DEPARTMENT OF THE AIR FORCE
377th Civil Engineer Division (AFMC)

SUBJECT: *Stage 2 Abatement Plan Modification Addendum May 2009*, Bulk Fuels Facility,
Kirtland Air Force Base (AFB), New Mexico

Stage 2 Abatement Plan Modification Addendum May 2009, Bulk Fuels Facility, Kirtland Air Force Base (AFB), New Mexico

Figure 1.
Location of Proposed
Groundwater Monitoring Wells

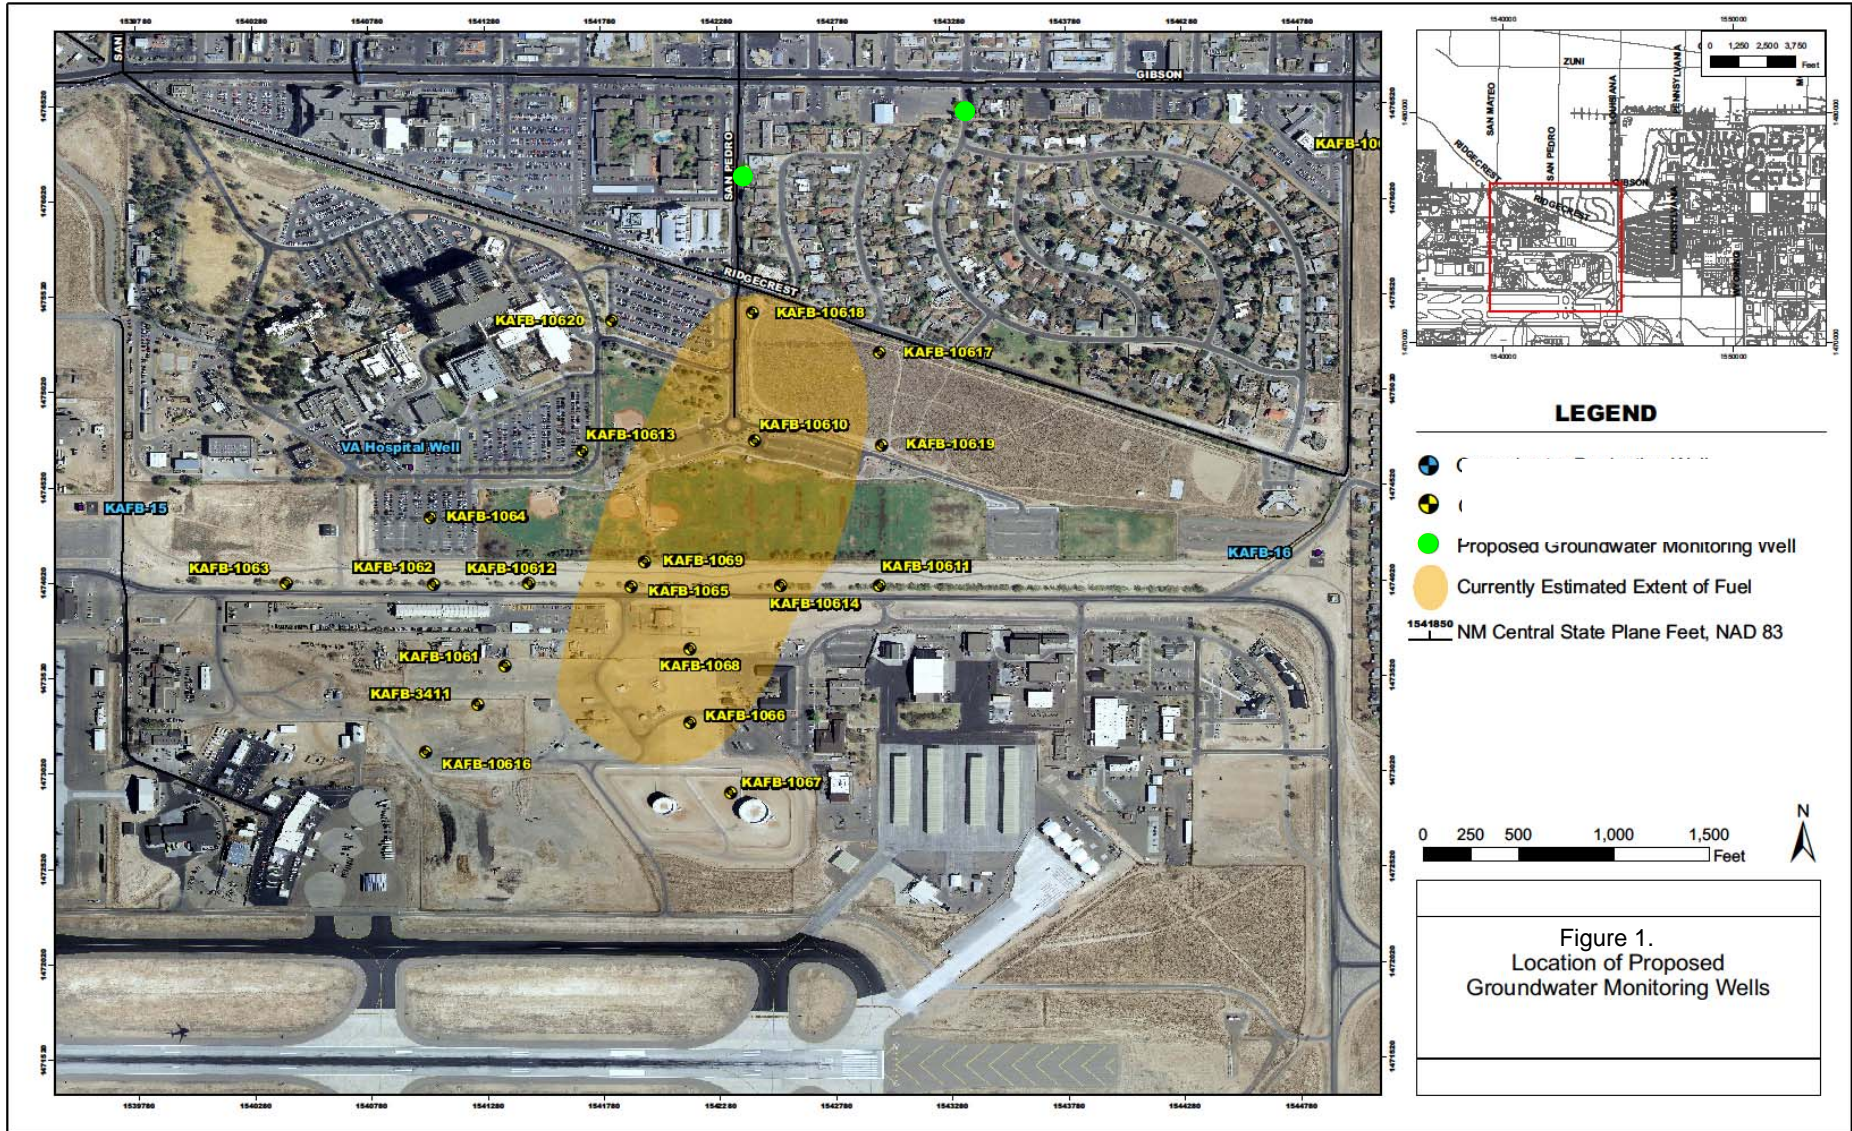
3. Figure 1 identifies the first two proposed locations. The location on San Pedro Avenue is proposed to target delineation of the north-northwest edge of the PSH plume and dissolved phase impacts north of the less than 0.01 foot thick sheen of PSH present in well KAFB-10618. The well location on Dakota Avenue is proposed to delineate the downgradient extent of both PSH and dissolved phase impacts to groundwater. Both of these well locations will be installed on City of Albuquerque right-of-ways associated with City streets. A third well location will likely be necessary to the northeast of well KAFB-10617; the exact location will be evaluated as drilling proceeds at the first location.

Figure 2. Proposed Drilling Schedule

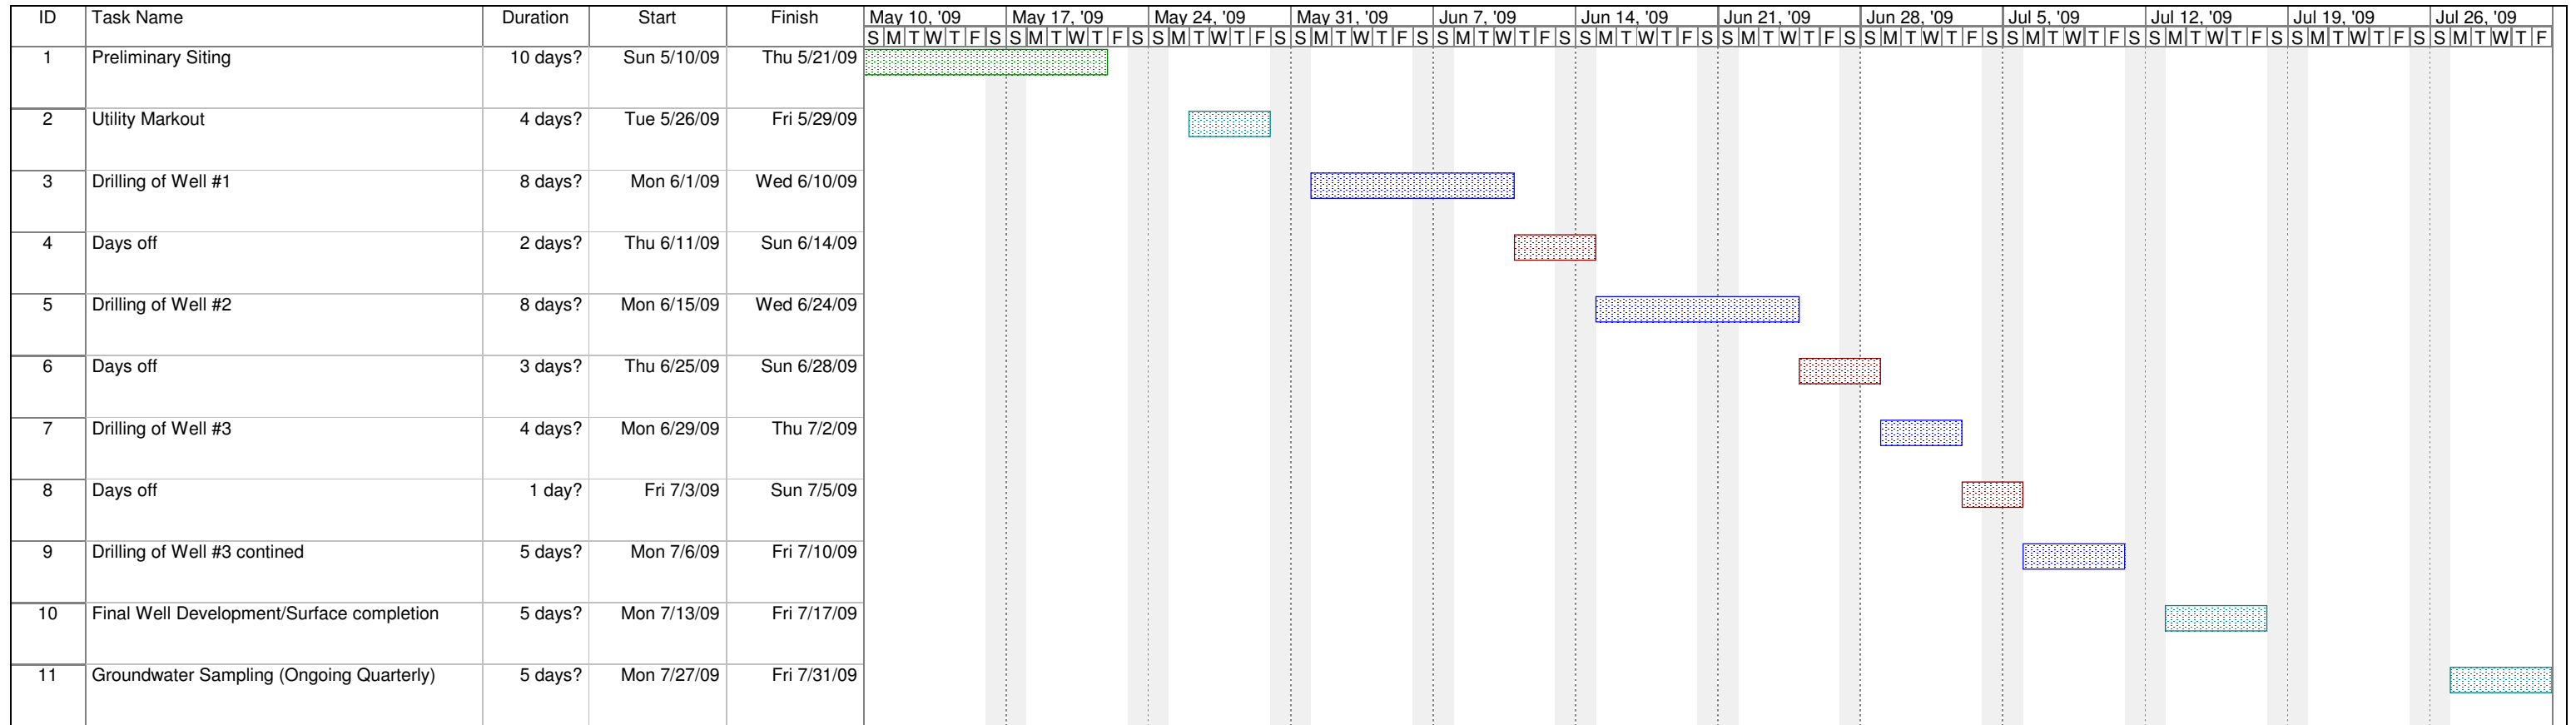
7. The anticipated schedule for installation of the initial off-base wells is to begin drilling activities the week of June 1, 2009. The expected drilling schedule for the first three wells is provided as Figure 2. Kirtland AFB will keep the NMED-GWQB informed of the drilling schedule as work progresses and seek concurrence from the NMED-GWQB on the overall schedule and progress.
